Class Rule Change

International Dart 18 Association

Effective date: 27/03/2018

Amendment One

Jib strop

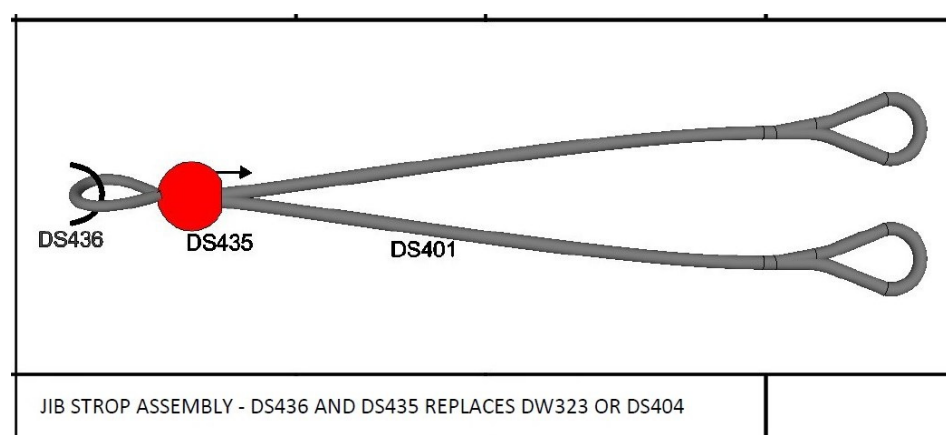
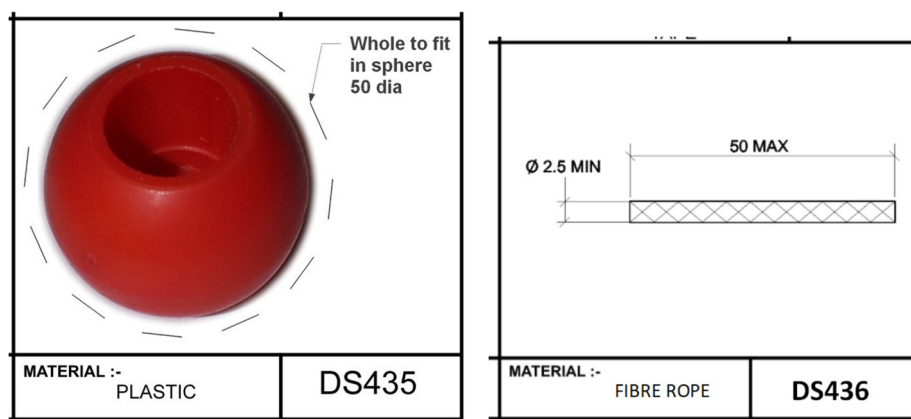
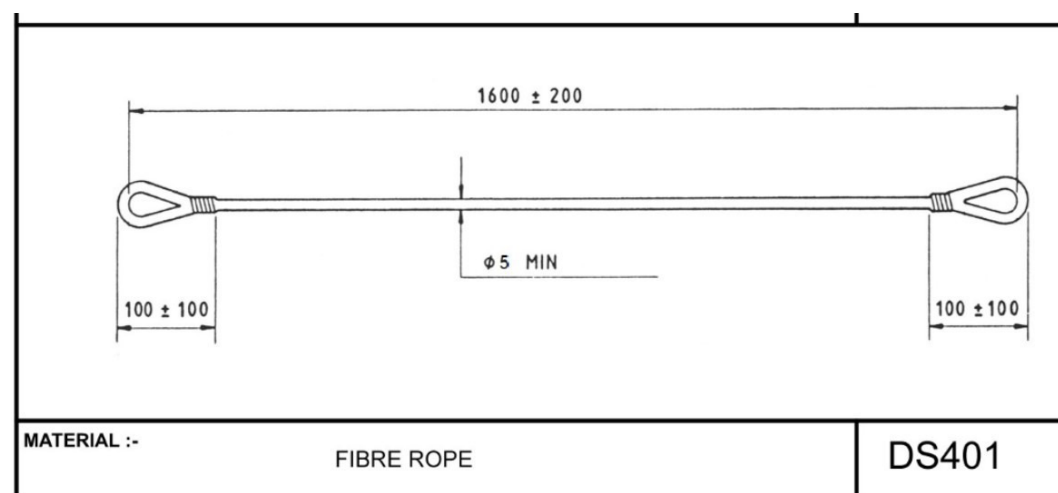
The snap hook DS404 can now be replaced with a ball and short length of line. The minimum diameter of the jib strop is reduced to 5mm. [Length unchanged.]

Add: Part DS435 and DS436

Amend: Minimum diameter of the jib strop is 5mm

Method of attaching the jib stop to the jib

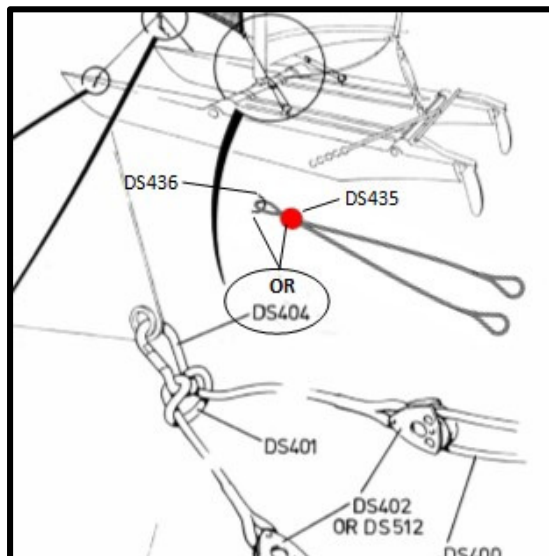
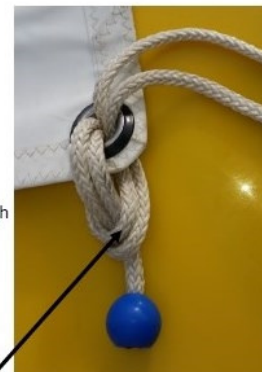
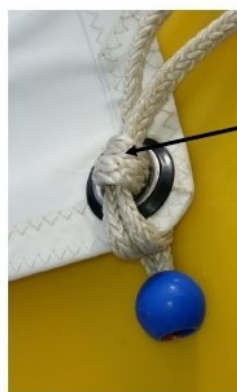
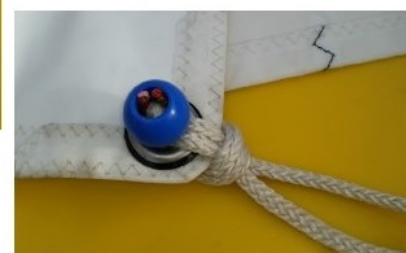
Pass the ball through

Pull the loops back

Tighten and the stop

Trapeze adjuster Part DW284

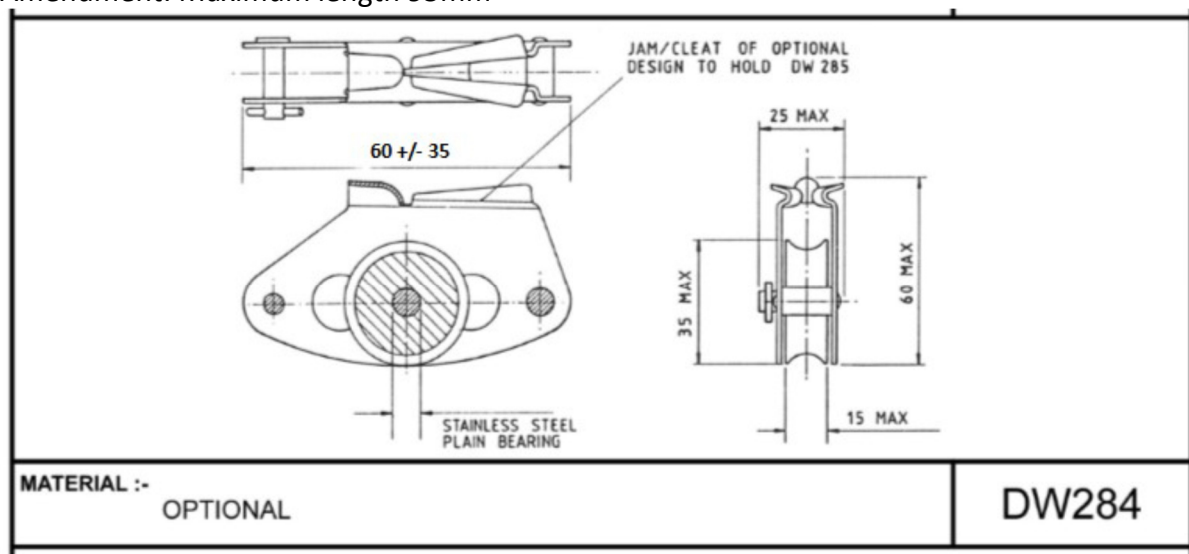
Amendment: Maximum length 95mm
